SAN FRANCISCO PLANNING DEPARTMENT

Memo to the Planning Commission

Date: April 24, 2014
Case No.: 2013.0314D
Project Address: 1110 Ashbury Street
Permit Application: 2013.04.05.3911
Zoning: RH-2 (Residential House, Two-Family)
40-X Height and Bulk District
Block/Lot: 2629/021
Project Sponsor: Bill Pashelinsky
197 Hayes Street
San Francisco, CA 94117
Staff Contact: Jessica Look – (415) 575-6812
jessica.look@sfgov.org
Recommendation: **Do not take DR and approve the project as proposed.**

1110 Ashbury St.: Nearly 100% Lot Coverage Proposed

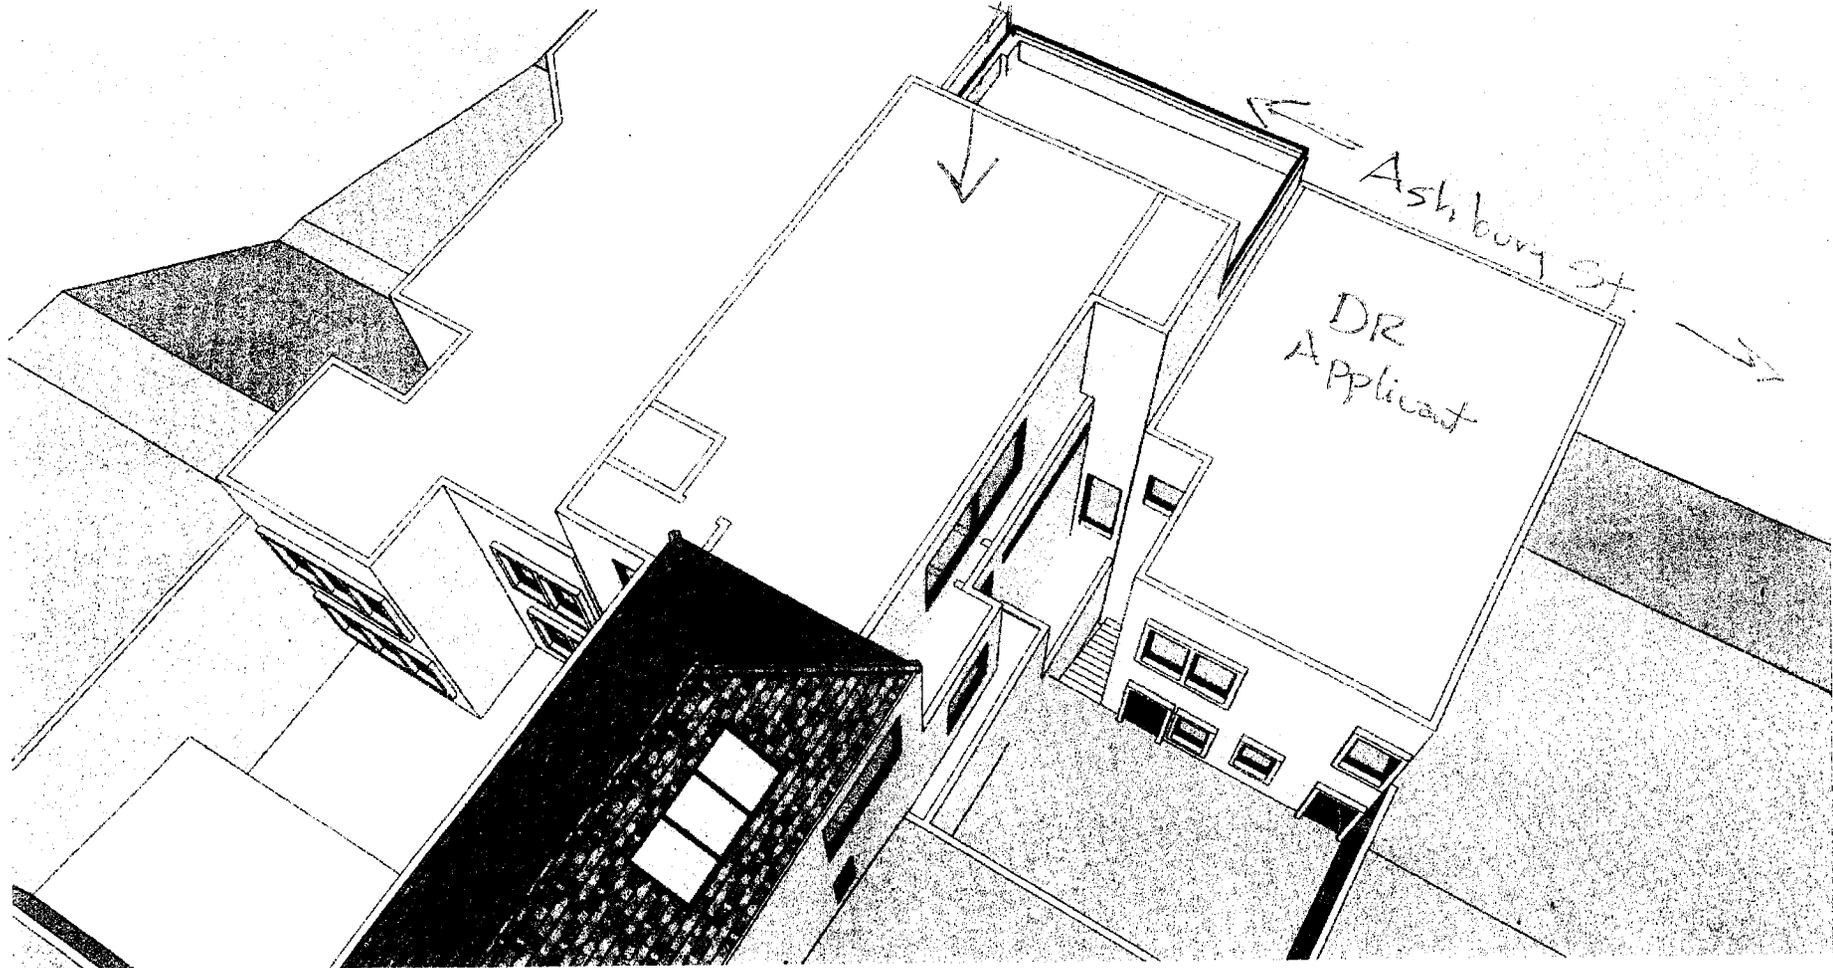
1. This project covers almost 100% of its lot because of an inequitable interpretation of the Code. (SEE SANBORN MAP ATTACHED.) The Planning Code requires a 25-45% rear yard in an RH-2 Zoning District. A published interpretation of the Code requires 25% of undeveloped lot area between buildings in lieu of a standard rear when there is an existing noncomplying rear building on the lot and the owner proposes a new building at front. In order to skirt the rear yard requirement and its related interpretation altogether, the current proposal plans to link the old and new structures and provide no (ZERO) open space on the lot other than the entirely substandard rear yard of about 10 feet. The exceptional and extraordinary circumstances are as follows:

Existing + Proposed = nearly 100%
lot coverage!

Issue #1: The project sponsor is proposing a front addition to a single-family house, and the final structure will remain a single structure. As such, a second structure does not exist, and therefore, the Planning Code Interpretation Section 134: Rear Yard, two buildings on a lot (Effective Date 11/86) does not apply. Furthermore, the entire proposed addition is within the buildable area, and no change to the bulk or size of the existing non-conforming structure is proposed. In response to the lot coverage percentage, the project sponsor states that the actual lot coverage is 83% and provides 875 usable open space (both in the rear yard and on decks).

Exhibit D

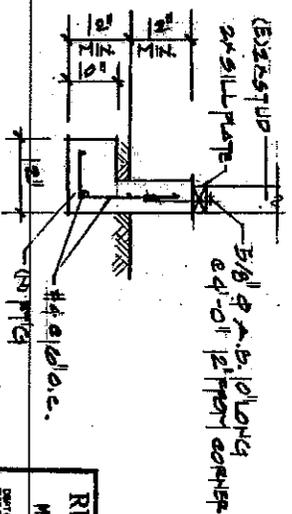
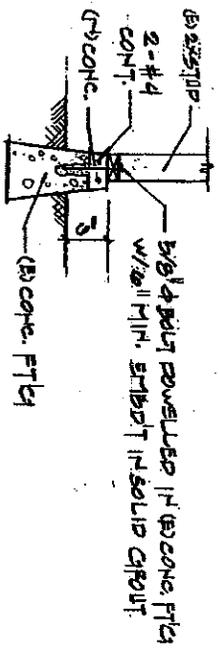
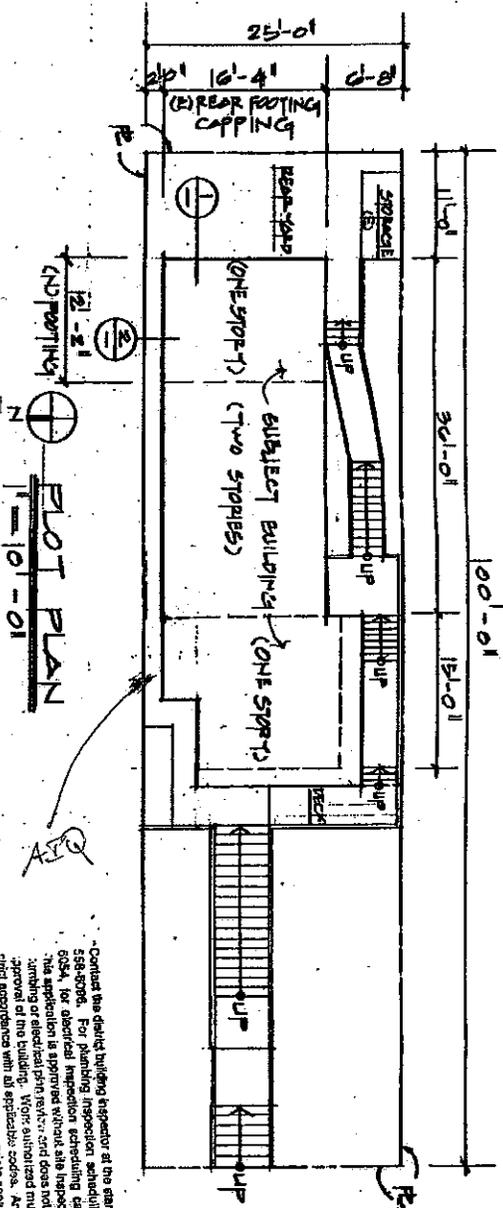
On March 4, 1996, the Building Department approved application number 09603527 for foundation work (See "Exhibit C"). This is the first available permit with drawings (See Exhibit D".) The drawings attached to the permit, show the entire front addition, including the Addition In Question. As these were foundation plans, they were not reviewed by the Planning Department. Still, they do show the Addition In Question as Existing. Furthermore, the permit specifies to Cap the existing concrete footing, which resides below the Addition In Question. In other words, the structural work was done on a portion of the foundation, under the Addition In Question, which was a part of the structure, at the time of the application. This permit reinforces the claim that the Addition In Question was previously permitted.

ATTACHMENT 1

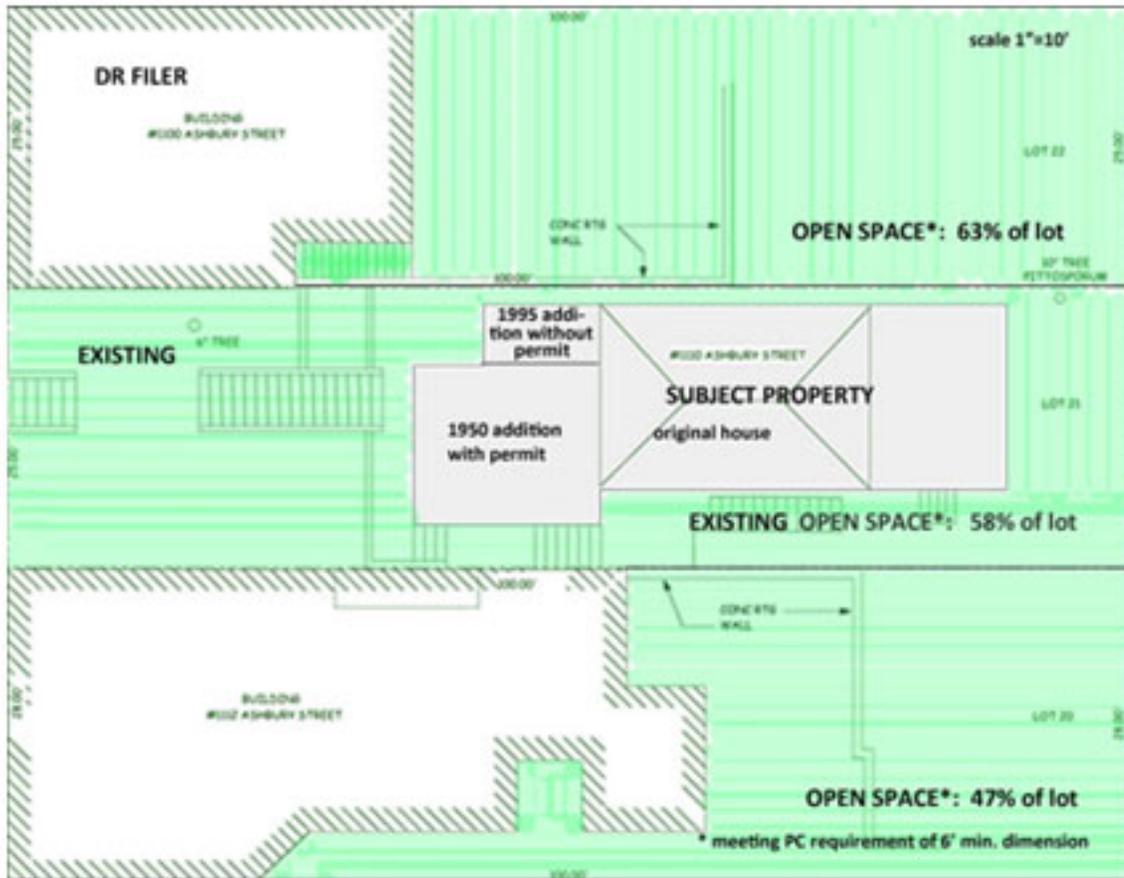
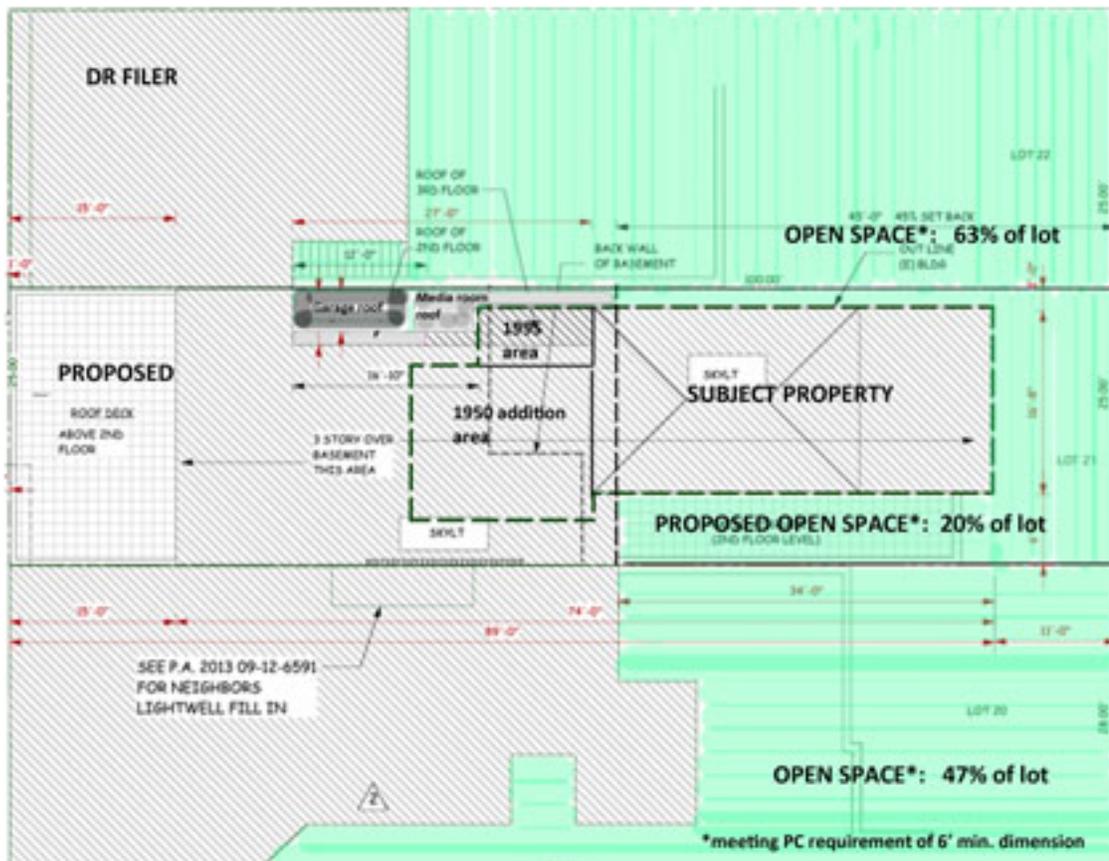
Proposed Site Plan
80% lot coverage

1110 ASHBURY: Rear View

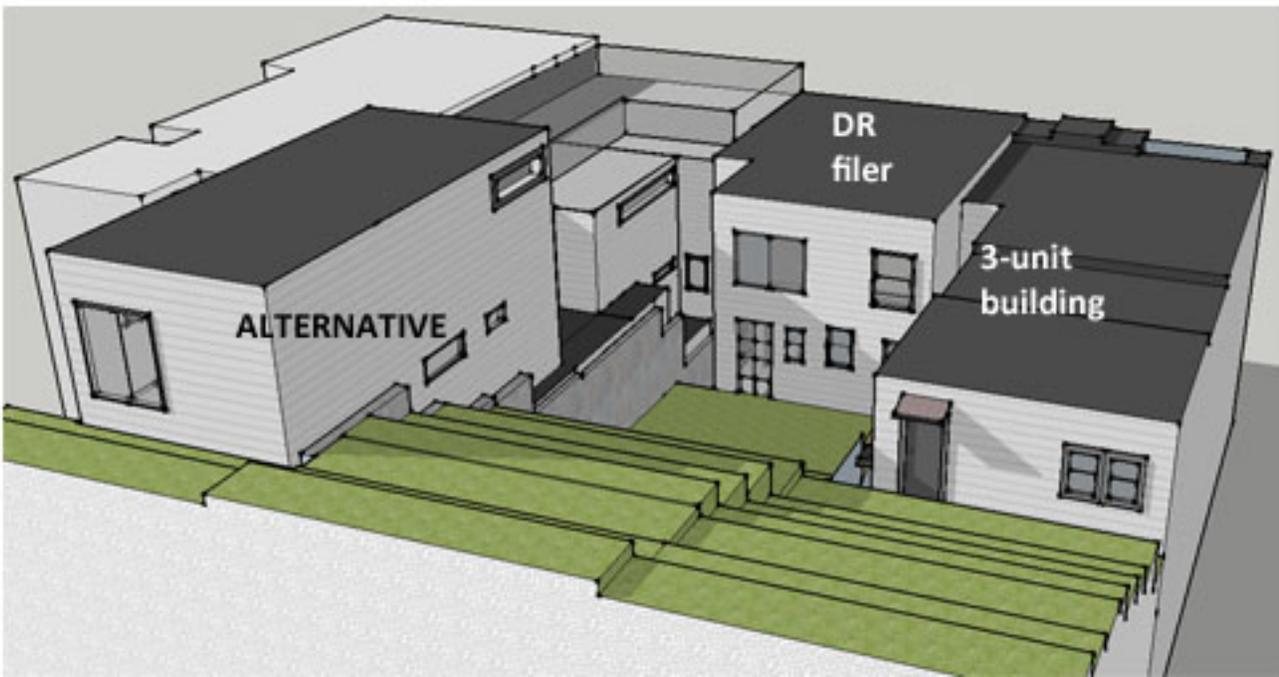
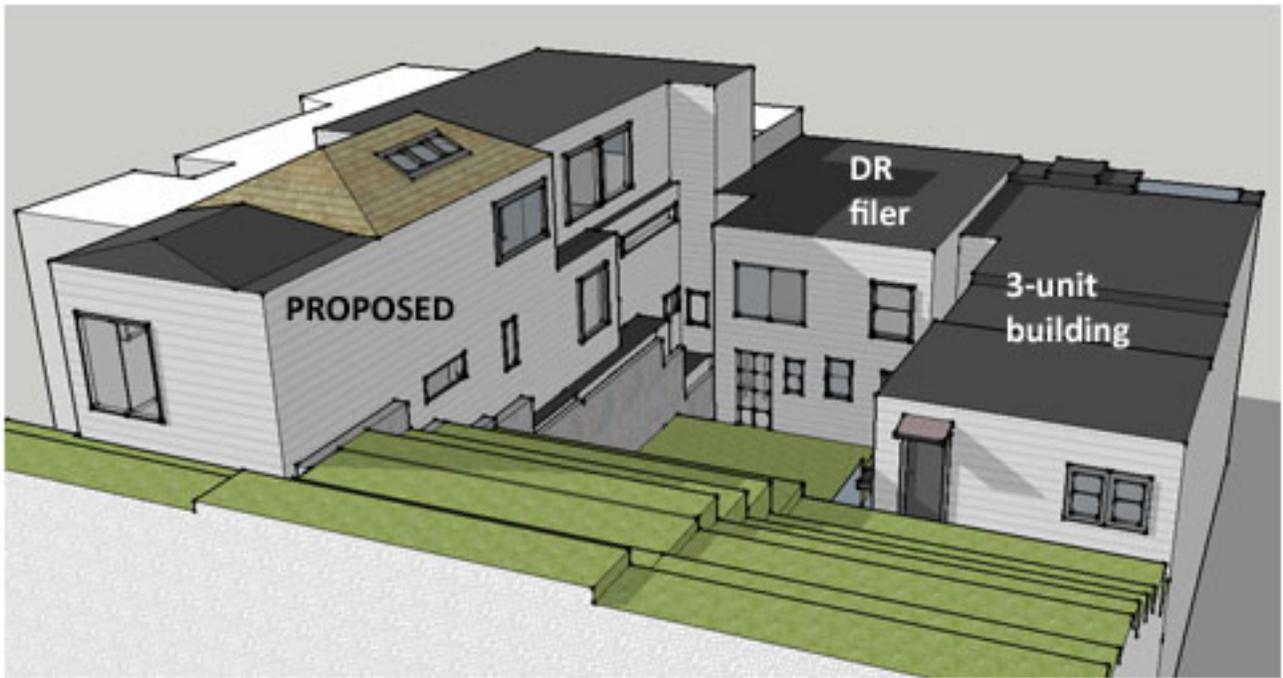
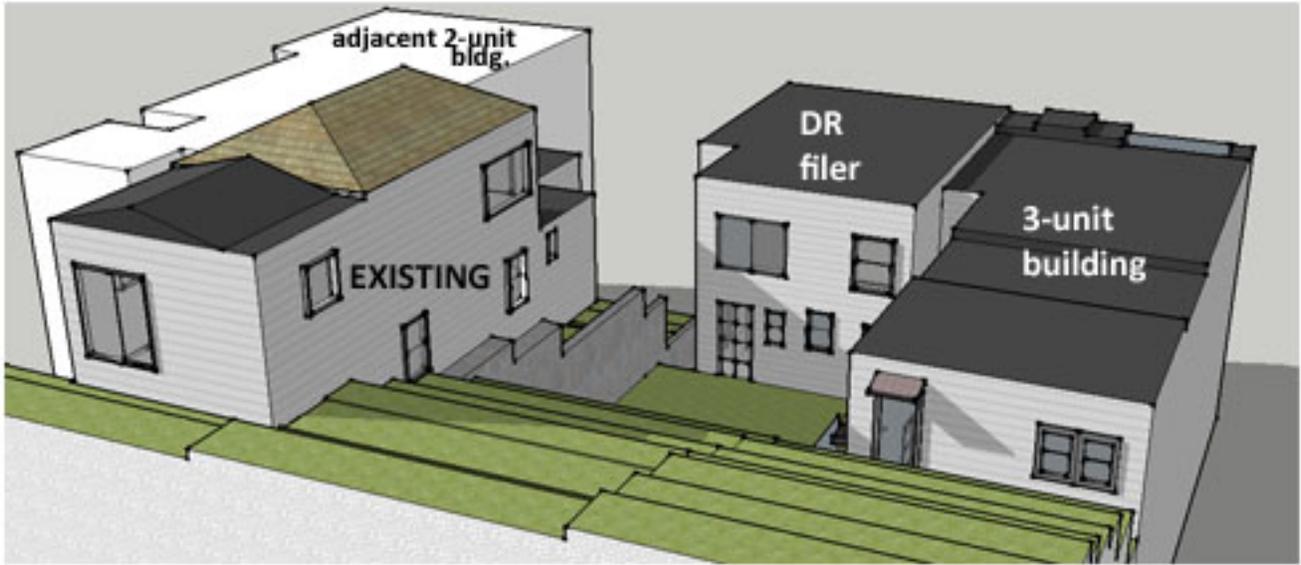
Winter Solstice Noon

ATTACHMENT 4

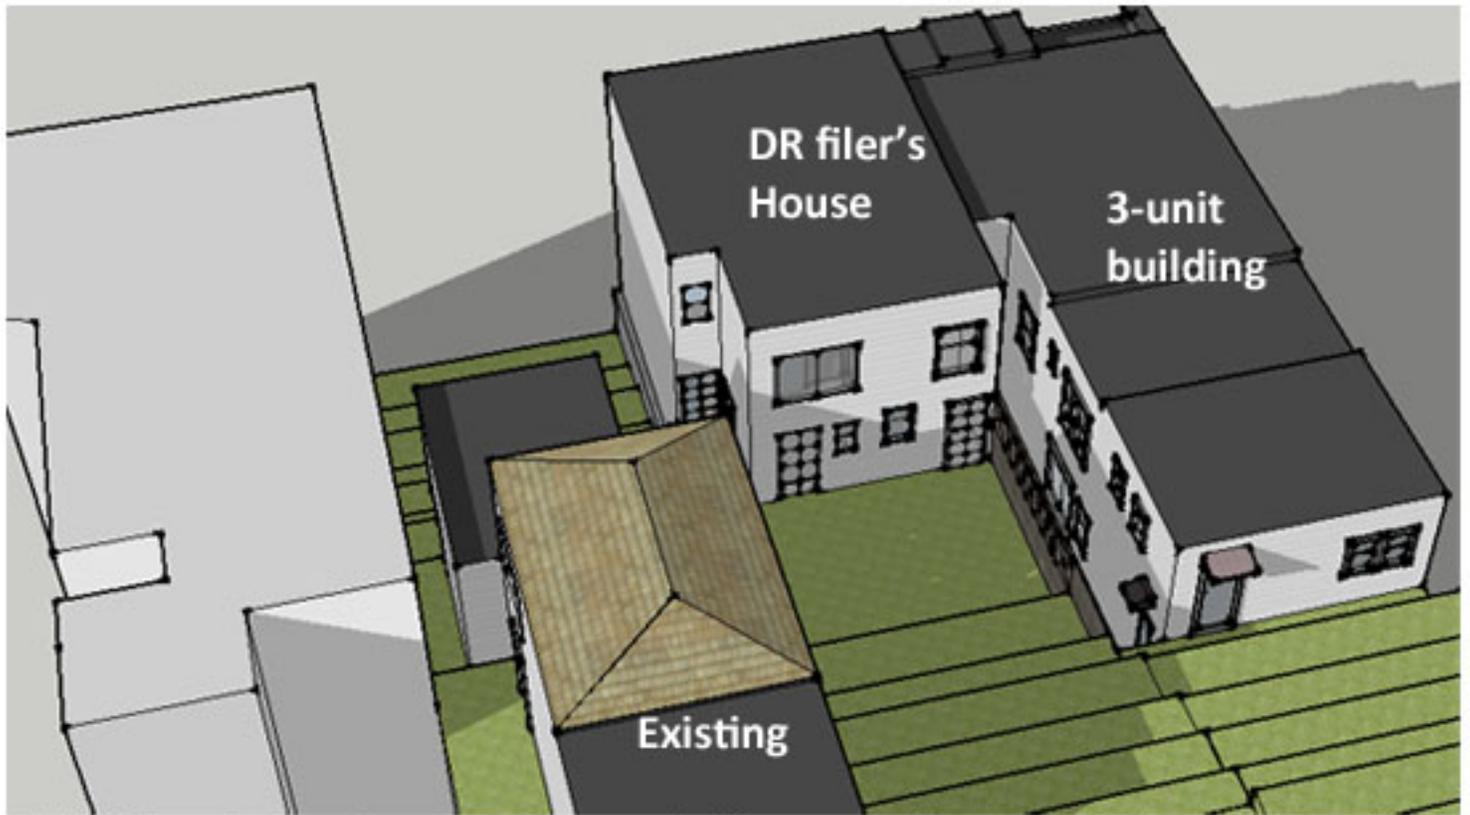
Existing circumstance: winter solstice noon (1 pm with daylight savings) when more than 50% of glazed area on back wall on the DR filer's house is in sun, as is all of the bedroom window in the lightwell.
